Reference	SSM71952
Models	Defender / L316
Title	Defender 07MY onwards – Transmission Output Shaft TUD500020 Greasing
Category	Driveline
Last modified	18-Aug-2014 00:00:00
Symptom	505000 Manual Transmission Concerns
Attachments	Greasing TUD500020.pdf (Greasing TUD500020.pdf)

Defender MT82 6 speed Transmission Extension shaft and Flange 2007MY onwards

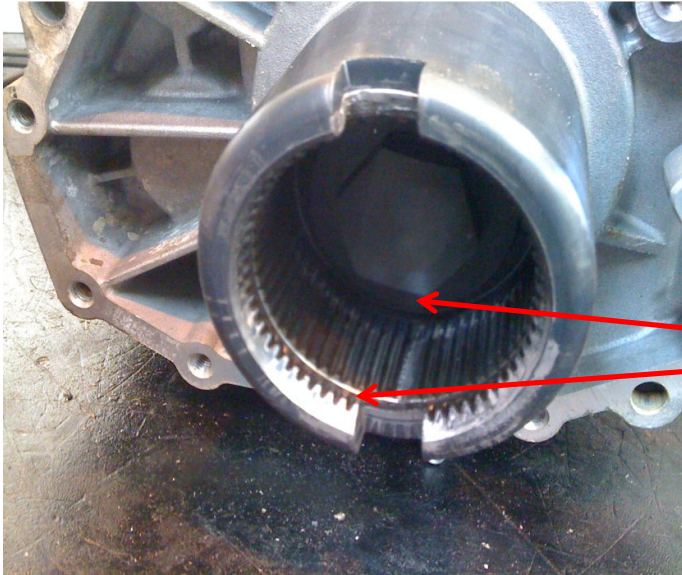
Application of weicon grease required when the transmission output shaft is replaced.

If the transmission output shaft (part number TUD500020) is replaced in service on Defender vehicles from 2007MY onwards equipped with the MT82 6 speed manual transmission then weicon grease must be applied to the circumference of both the shaft and flange as shown in the attached document.

**Apply Weicon Grease
(part number IYX500050)
360 degrees between
the circlip and base of
the flange**

**Apply Weicon Grease
(part number
IYX500050) 360
degrees the entire
length of the splines.**
